APPLICATION FOR PLANNING APPROVAL

Application Number: DA-2024-170
Proposal: Change to exterior and signage
Subject Site: Shop 1/34 Mertonvale Circuit, Kingston
Responsible Planning Officer: Camilo Miranda

**RE: PROPOSED DEVELOPMENT/USE – SIGNAGE AT SHOP 1/34 MERTONVALE
CIRCUIT, KINGSTON DA-2024-170**

Figure 3: Property Zoning Commercial under the Scheme.

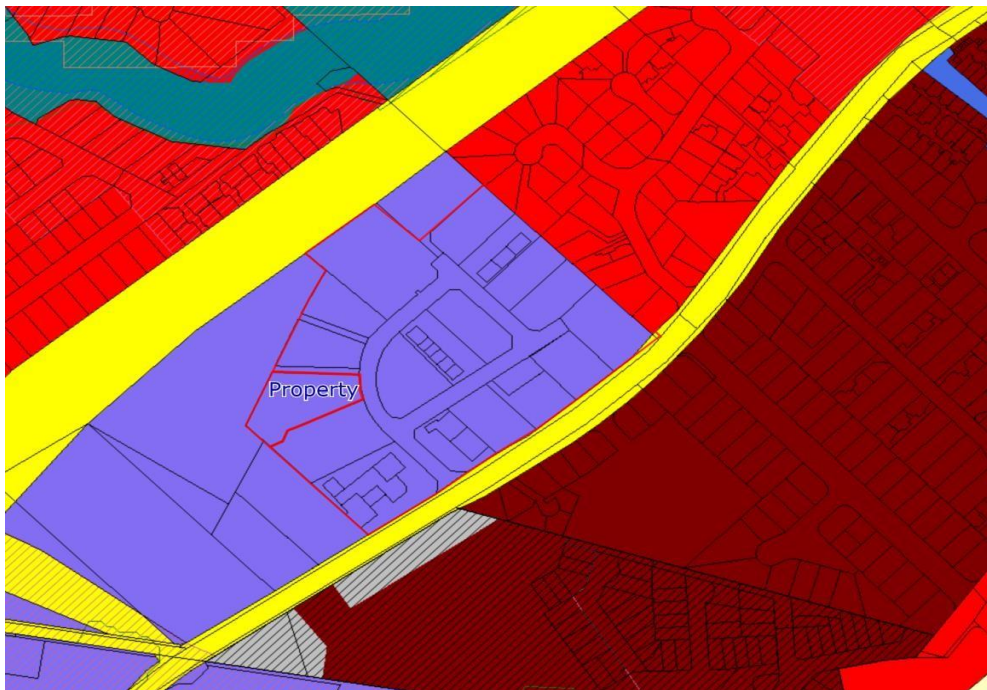
Zoning of the Property is Commercial under the *Kingborough Interim Planning Scheme 2017* (the Scheme) as shown in Figure 3.

Figure 11: Internal appearance of the store

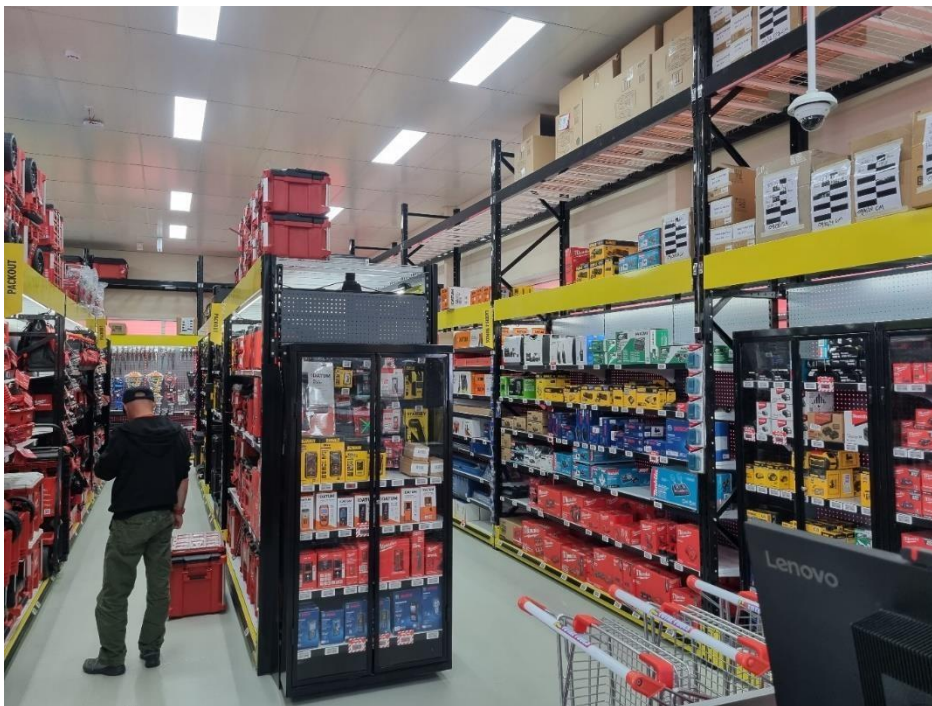
The internal layout of the store showing the height of the shelving is shown in Figure 11.
